SERVICE BULLETIN 00005

- Date Released:** August 24, 2020
- Date Effective:** August 24, 2020
- Subject:** Potential cracking of the EX-00017 and EX-00017-1 Cylinder #2 exhausts

- Affected Models:** All RV-12 model aircraft (RV-12iS not affected)
- Required Action:** Inspect EX-00017 or EX-00017-1 Cylinder #2 exhaust tube for cracks as described in this document. If cracks are found, replace the EX-00017 or EX-00017-1 with the EX-00017-2 **AND** replace the EX-00015 exhaust tube with the EX-00015-1.

FIGURE 1: CYLINDER #2 EXHAUST VARIANTS

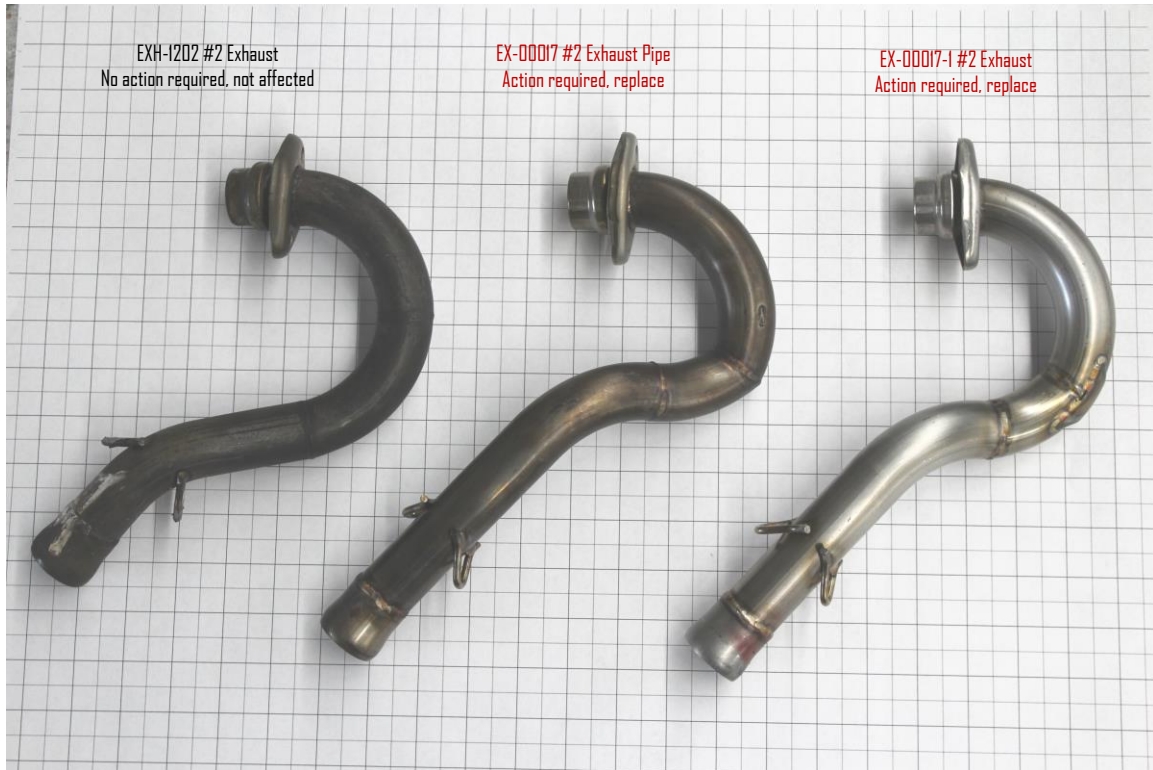
There are two Cylinder #2 exhaust tube designs (EX-00017 and EX-00017-1) that are affected by this service bulletin. You must inspect your individual aircraft to determine which specific part is installed, and whether action needs to be taken.

Experience in the field suggests that some EX-00017 and EX-00017-1 Cylinder #2 exhaust tubes are prone to fatigue cracking. Complying with this service bulletin will ensure aircraft equipped with the affected parts are operating with sufficiently durable parts, equivalent to aircraft equipped with newer parts.

Step 2: Inspect the Cylinder #2 exhaust to determine which part number is installed. Refer to Figure 1.

- If an EXH-1202 is installed, proceed to Step 8.
- If an EX-00017 or EX-00017-1 is installed, proceed to the next step.
